Subject: **Request for Modification to the Individual Section 404 Permit, Section 401 Water Quality Certification and Neuse Riparian Buffer Authorization** for the construction of the US 70 Bypass from east of SR 1556 (Wayne Memorial Drive) to east of SR 1323 (Promise Land Road) in Wayne and Lenoir Counties. State Project No. 34461.3.8. TIP No. R-2554BB&C.

The North Carolina Department of Transportation (NCDOT) requests a modification to the existing Individual Section 404 Permit, Section 401 Water Quality Certification and Neuse Riparian Buffer Authorization for the R-2554 BB and C project. This modification is being requested due to clarifications or revisions needed on the previous modifications dated December 27, 2012 and January 29, 2013, a study area change between the planning phase and final design, and a topographic error on plan sheets 47 and 47A. Enclosed with this request are updated permit drawings, an updated impact summary sheet, and updated borrow site mapping.

**R-2554BB&C
WETLAND SITE MAP
REVISED: 05-17-2013**

SHEET NO. 47

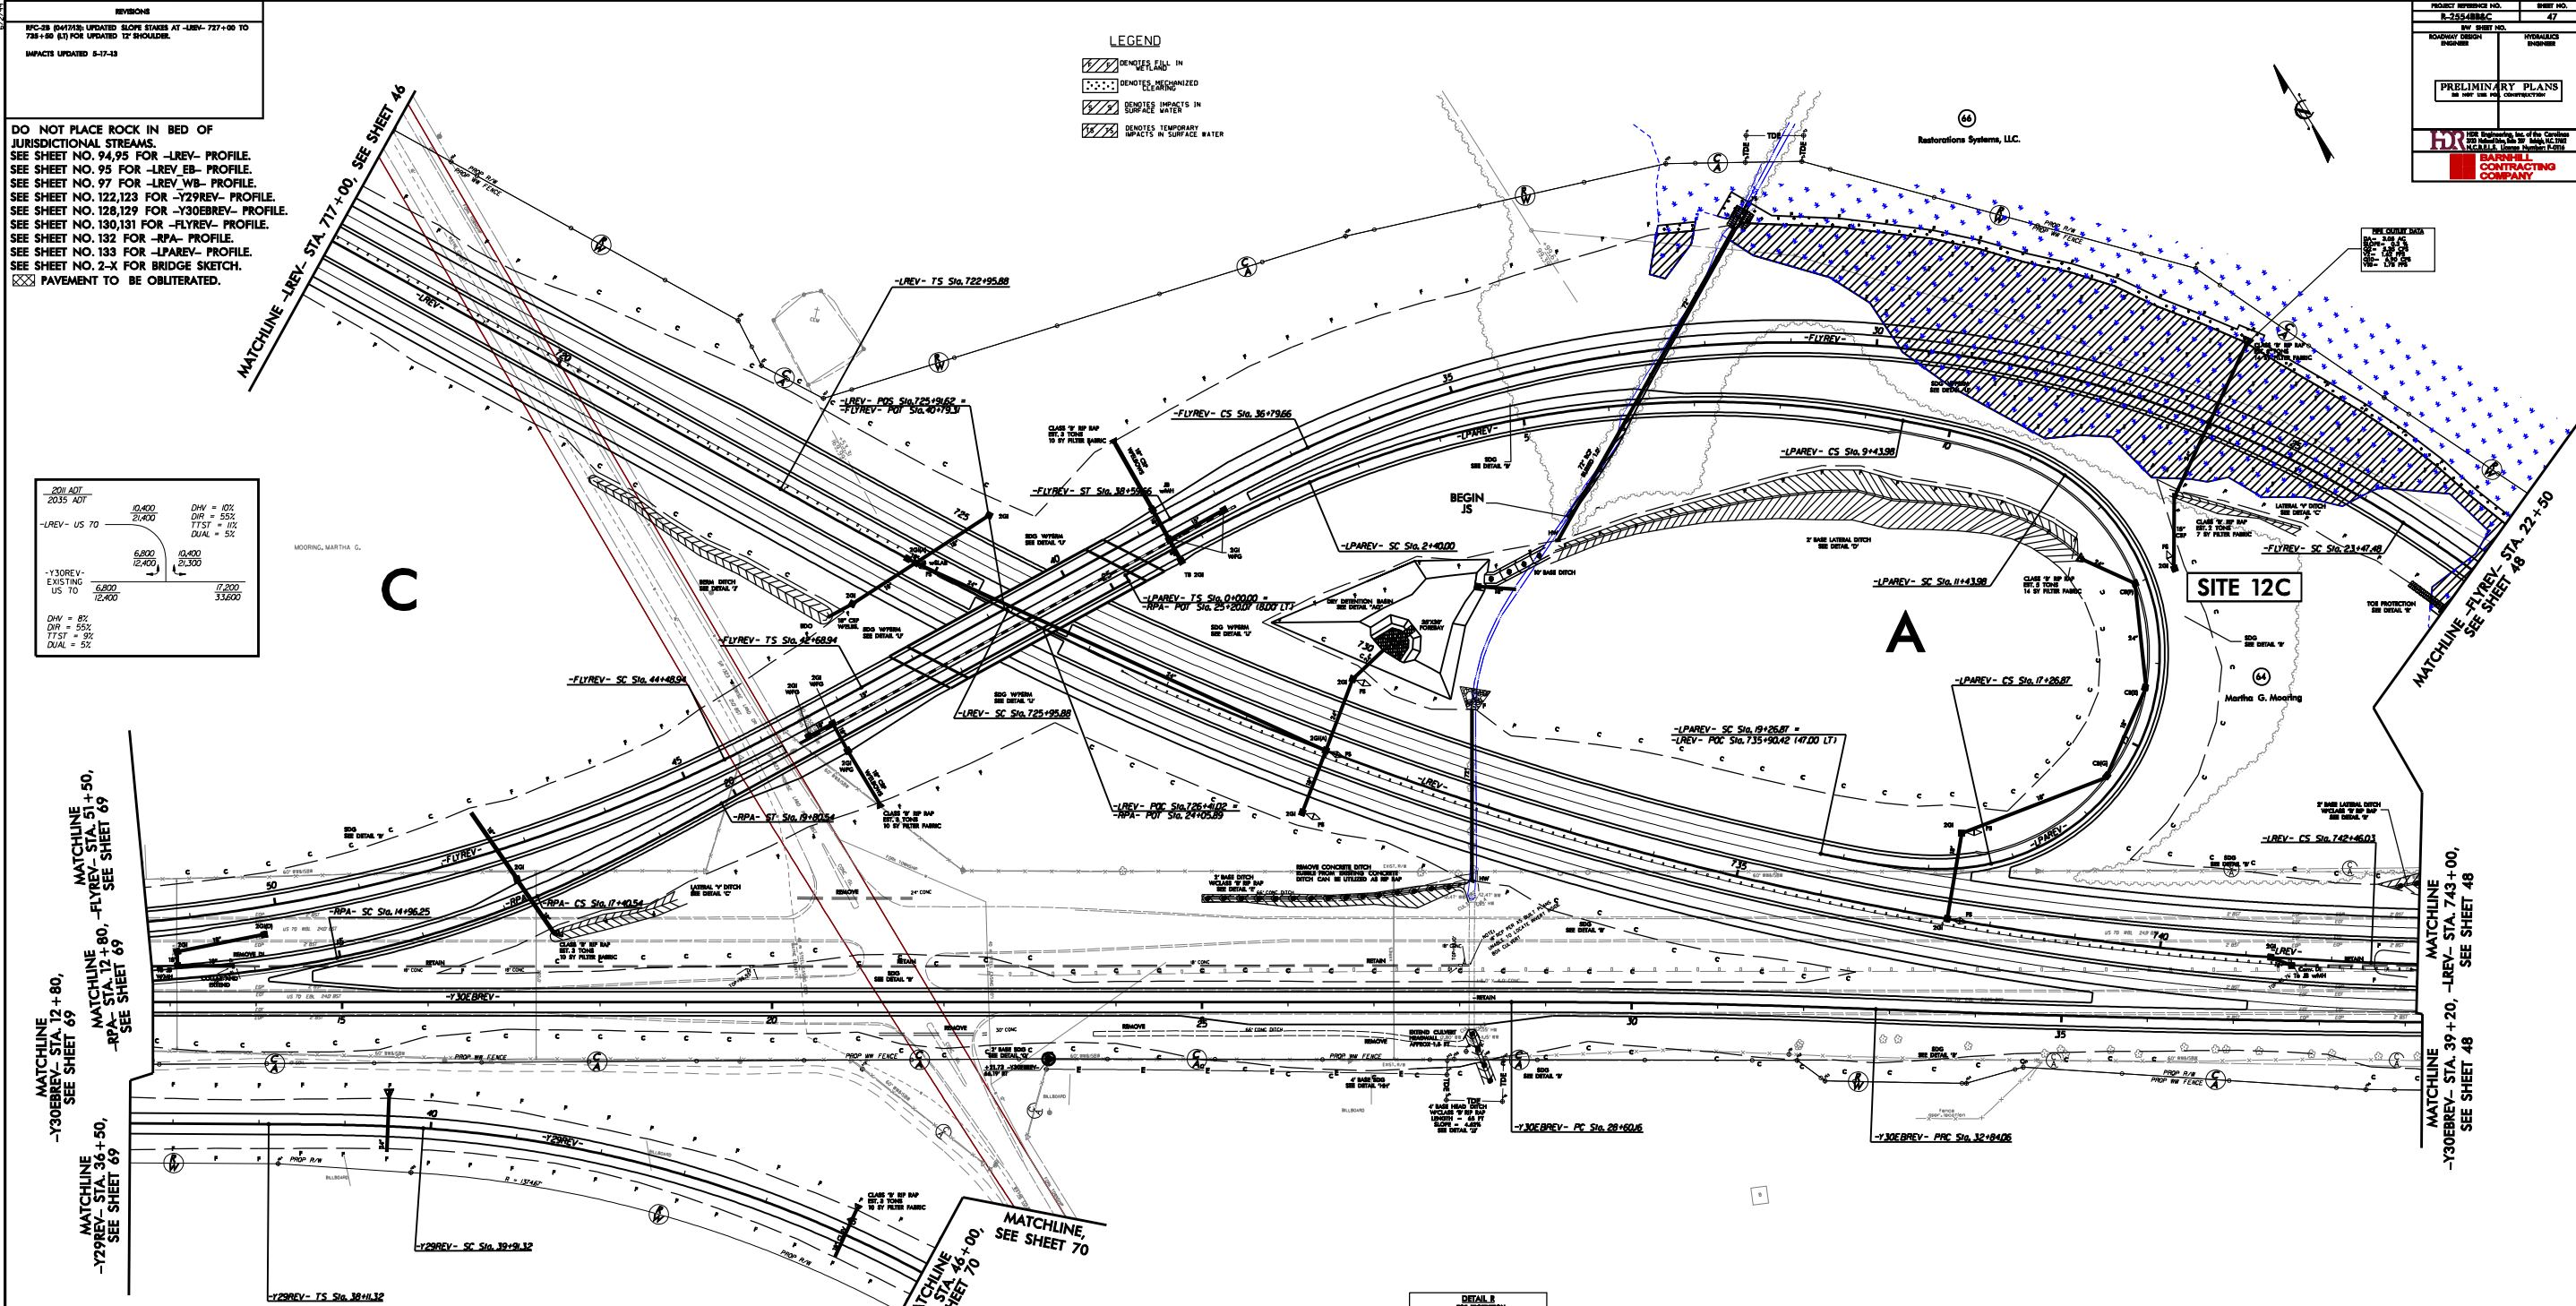
In addition to the study area change described above, a break in the topographic mapping caused an error on plan sheets 47 and 47A at Permit Site 12C. This was noticed while surveying the slope stake limits and the error results in the slope stake being approximately 12' beyond what was permitted. Permit Site 12C impacts will change slightly, adding 0.04 acre of additional fill while the amount of mechanized clearing remains unchanged.

RPC-28 (04/11/13): UPDATED SLOPE STAKES AT -LREV- 727+00 TO 728+50 (S) FOR UPDATED 12' SHOULDER.
IMPACTS UPDATED 5-17-13

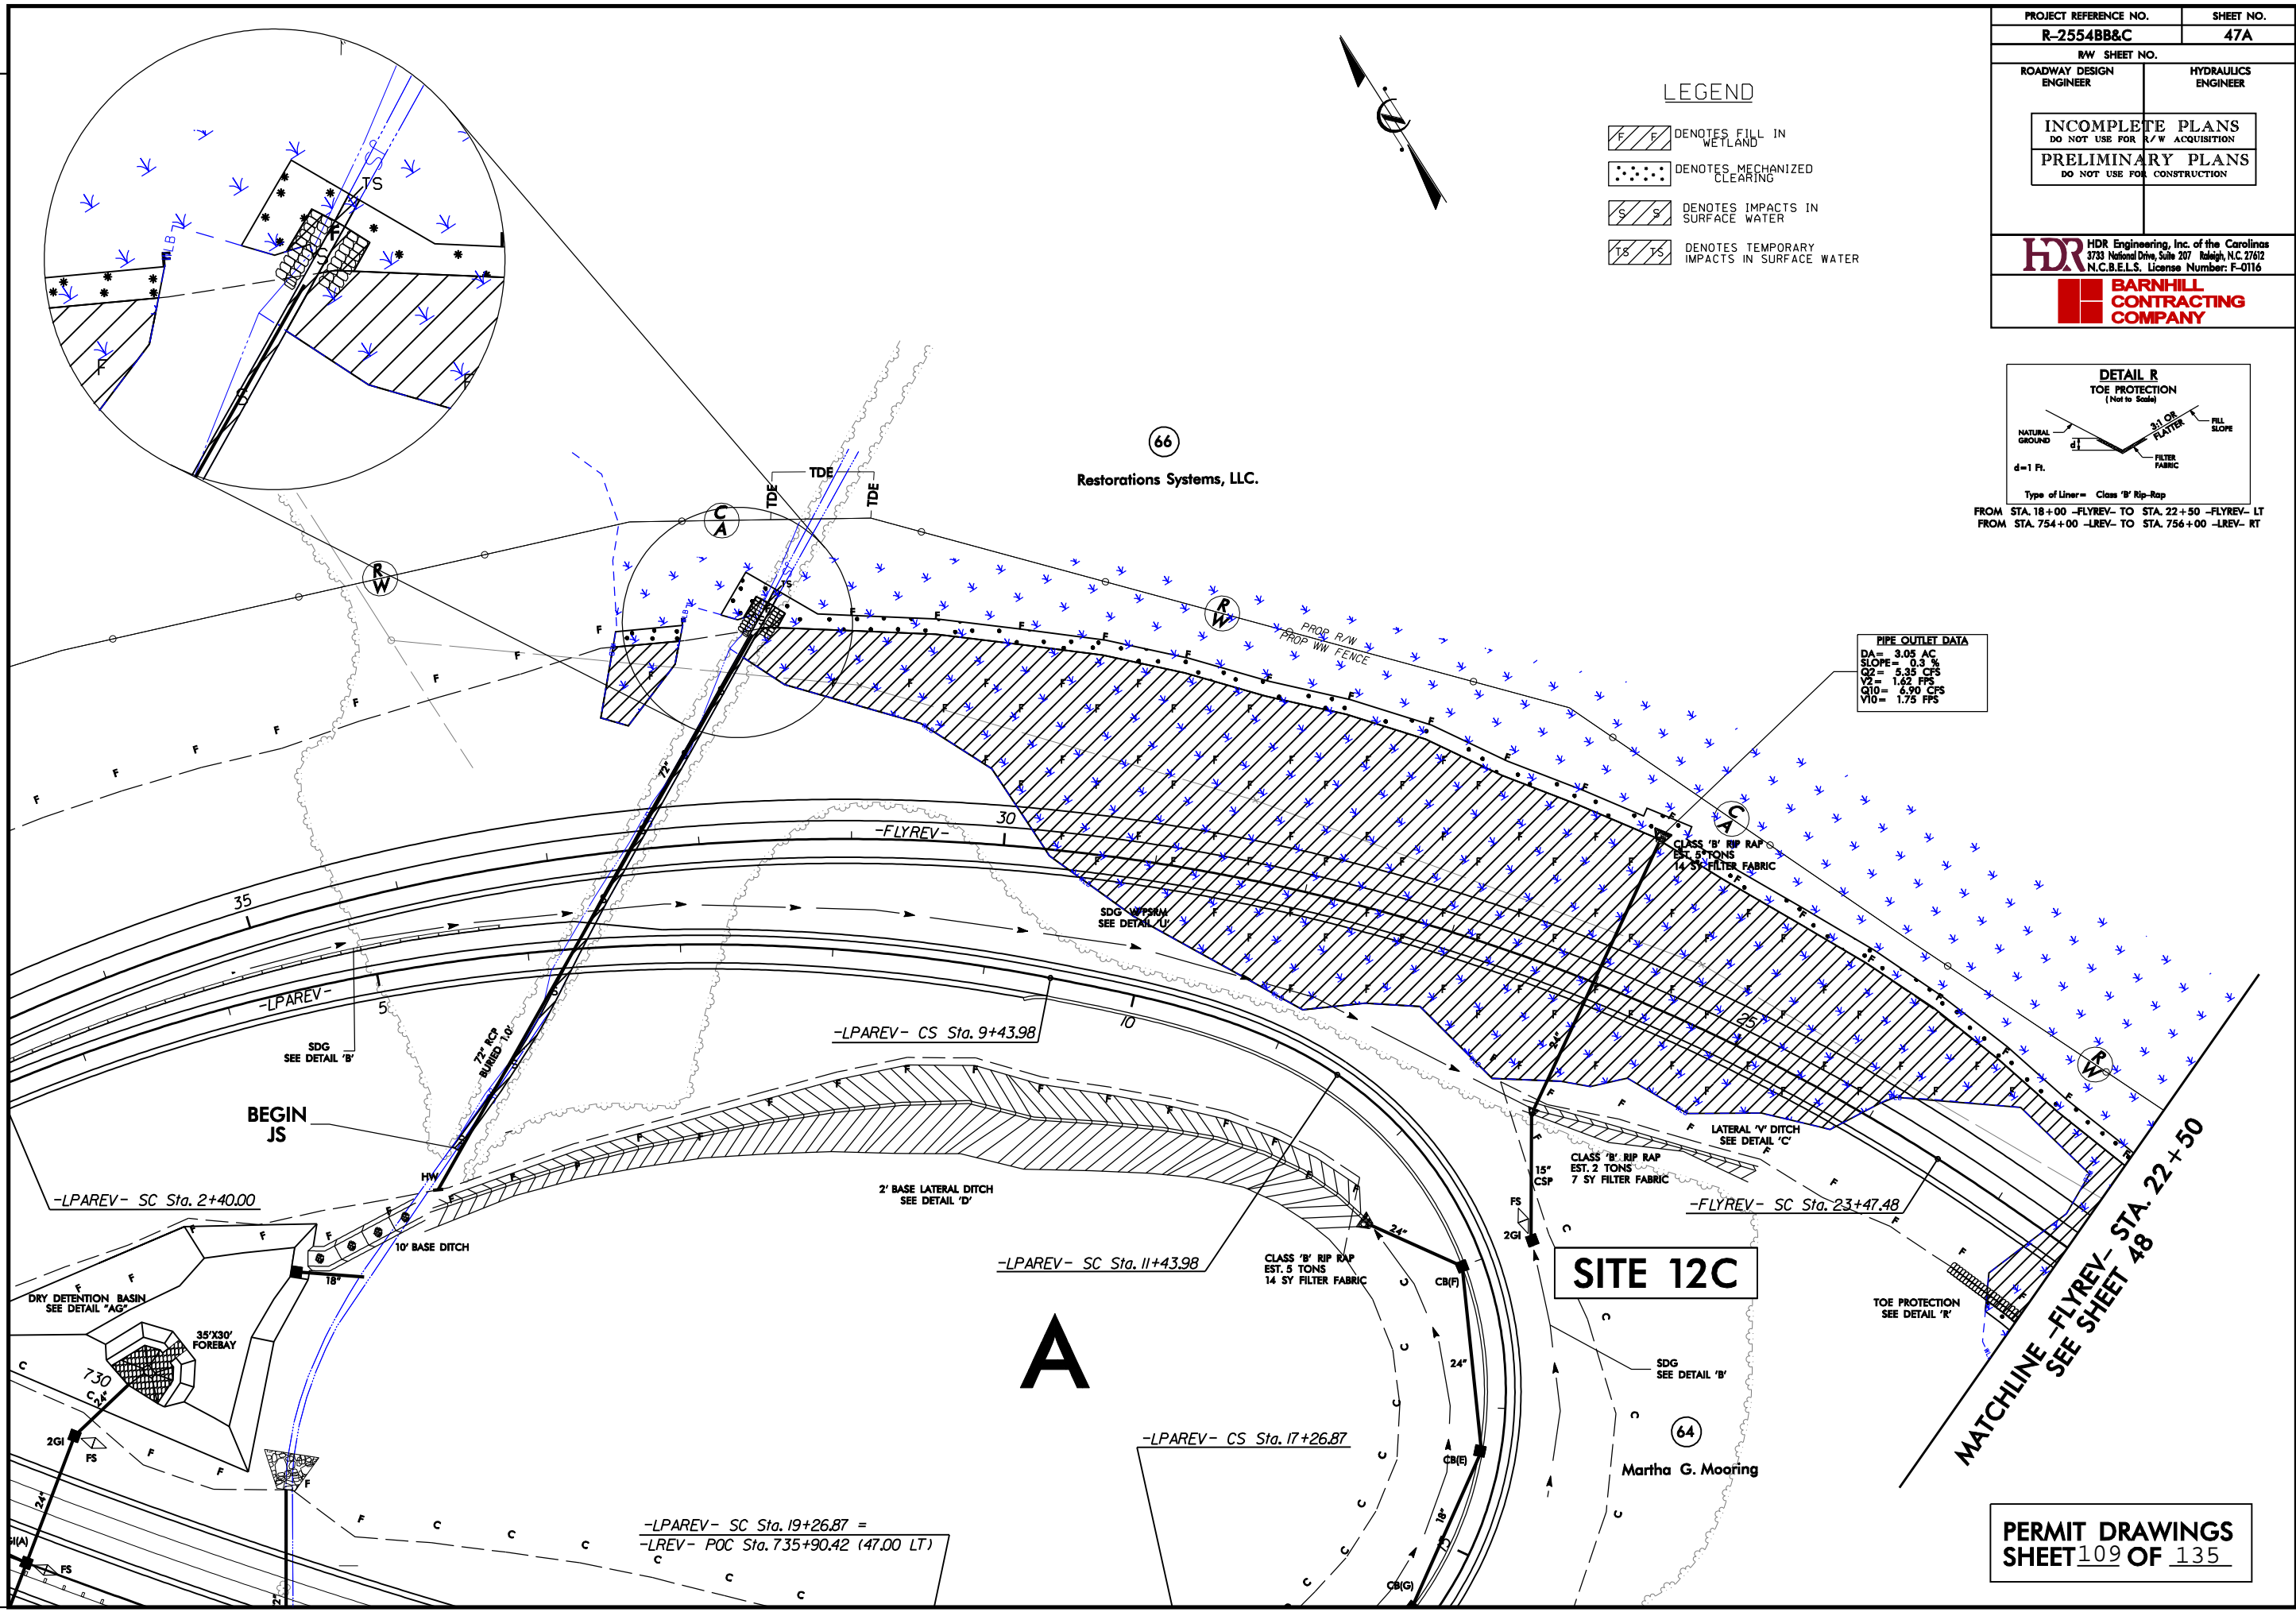
IMPACTS UPDATED 5-17-13

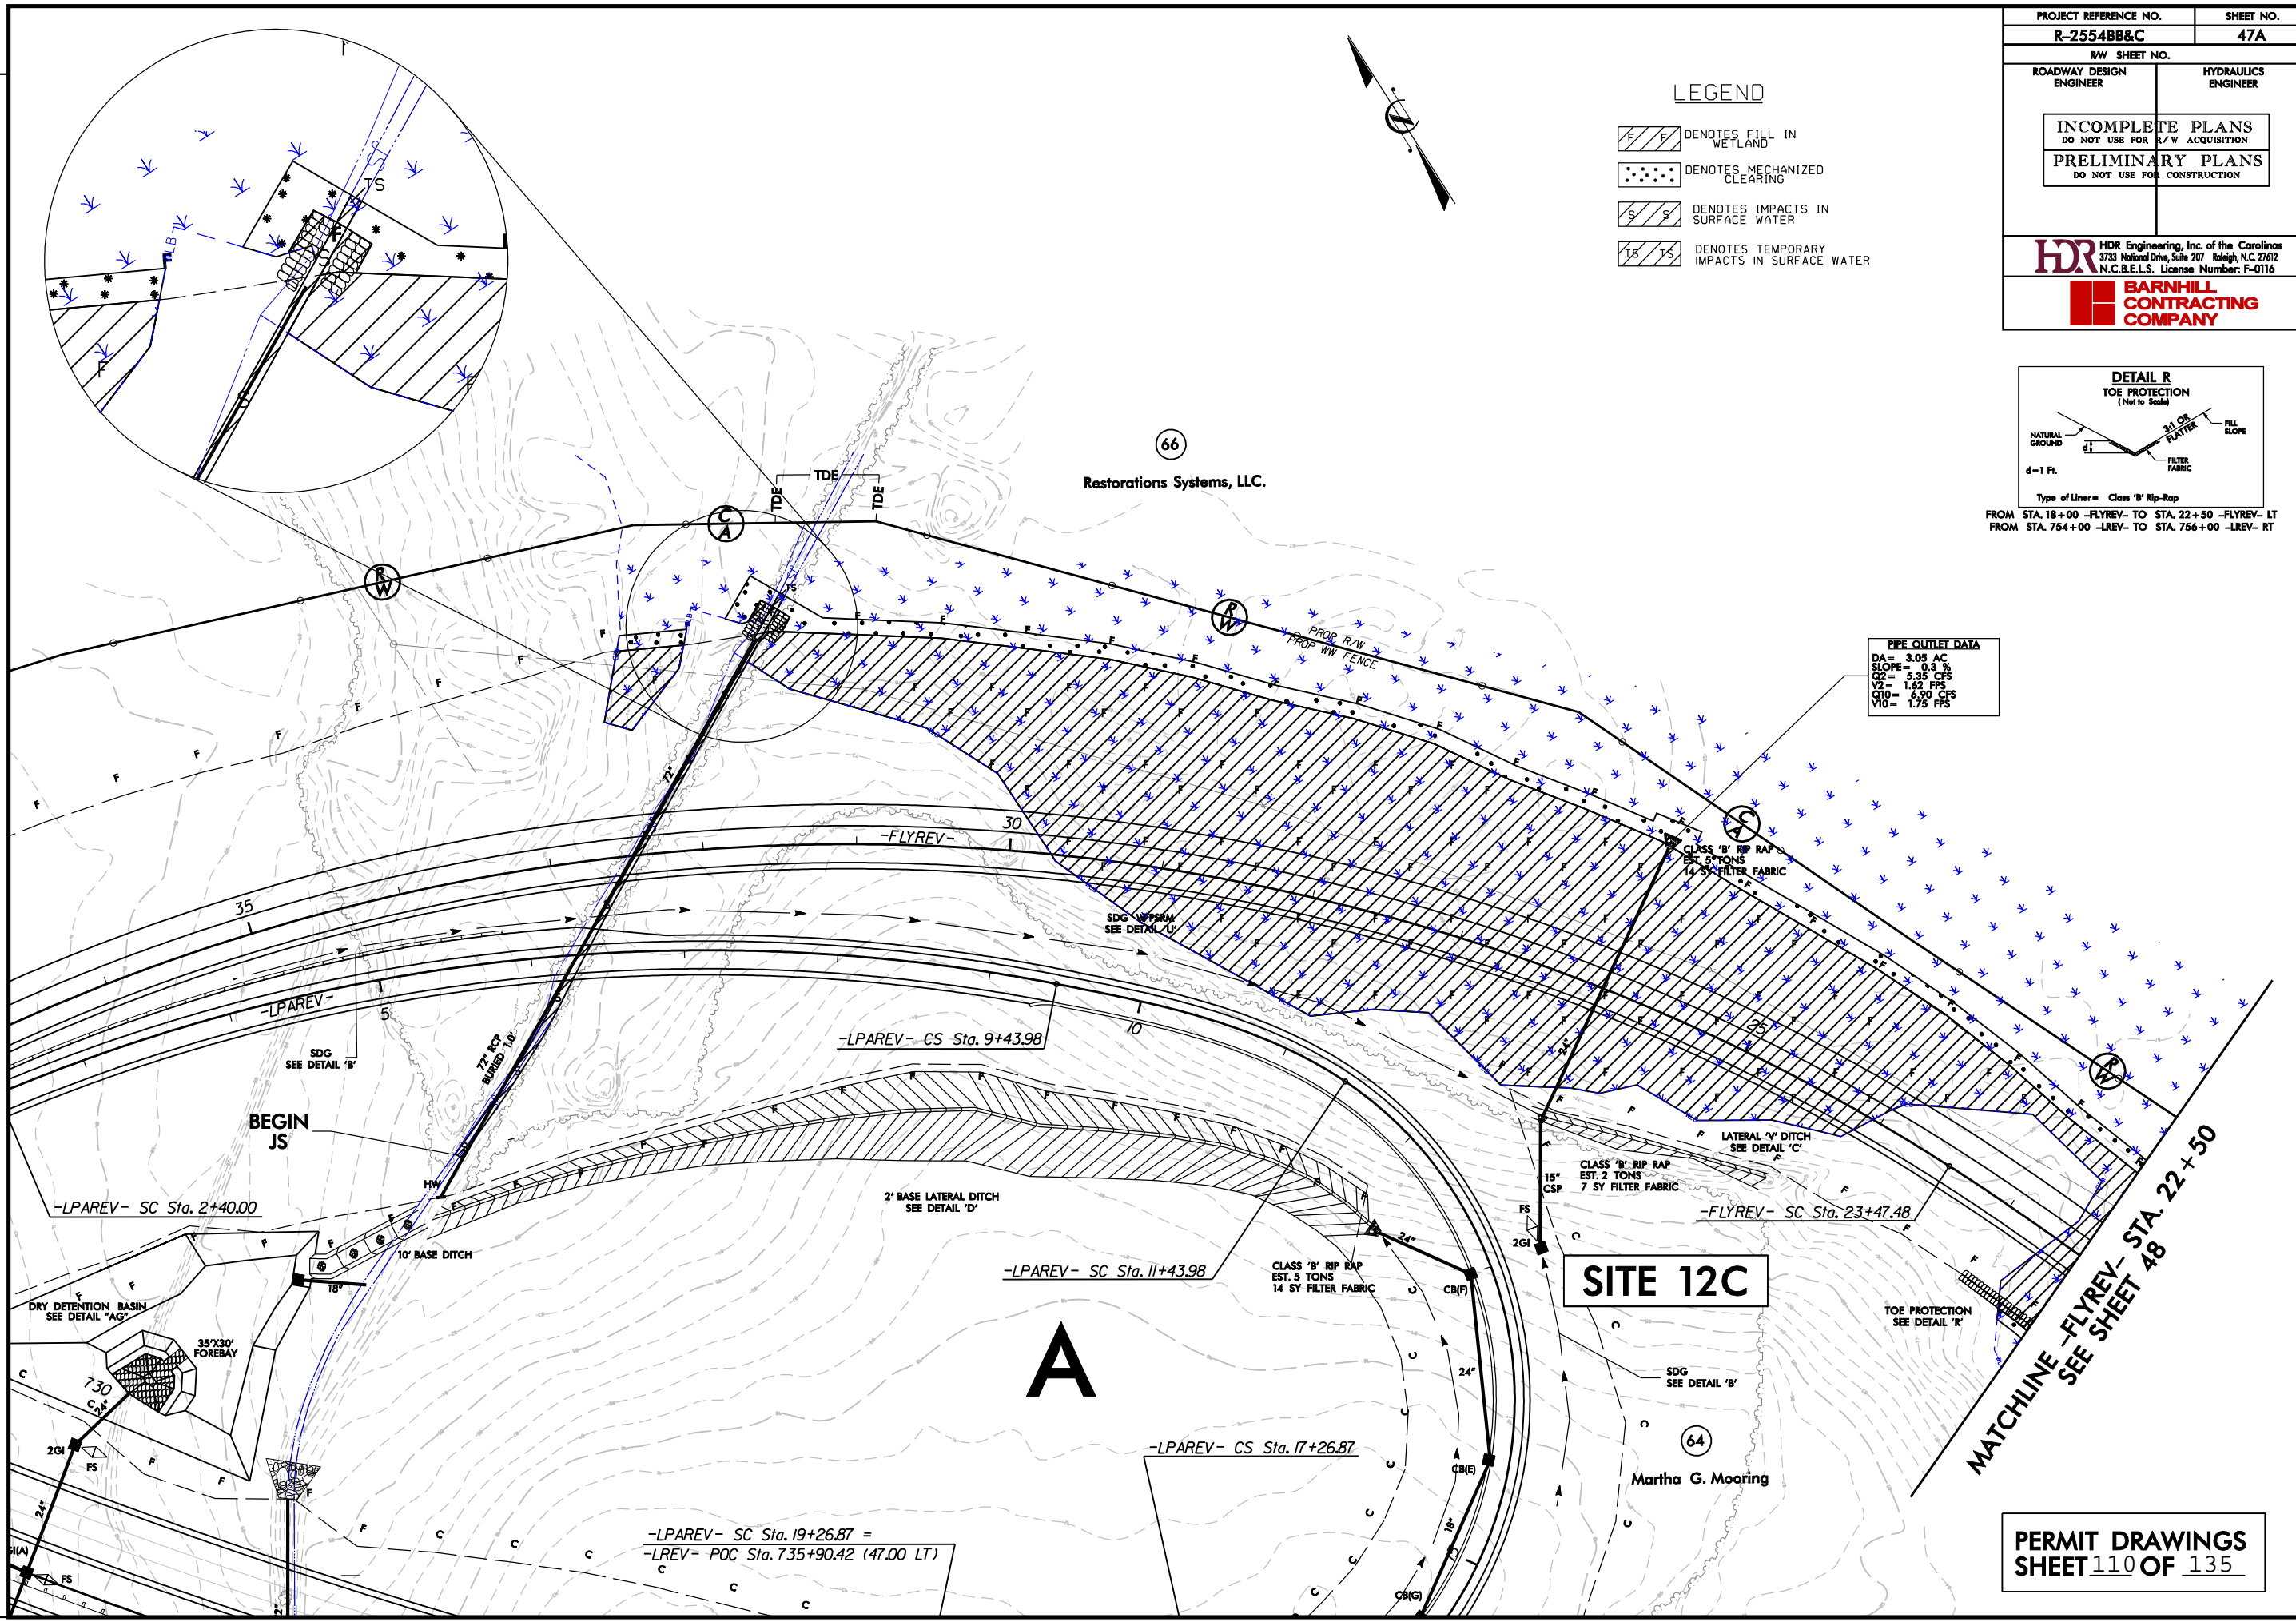
IMPACTS UPDATED 5-17-13
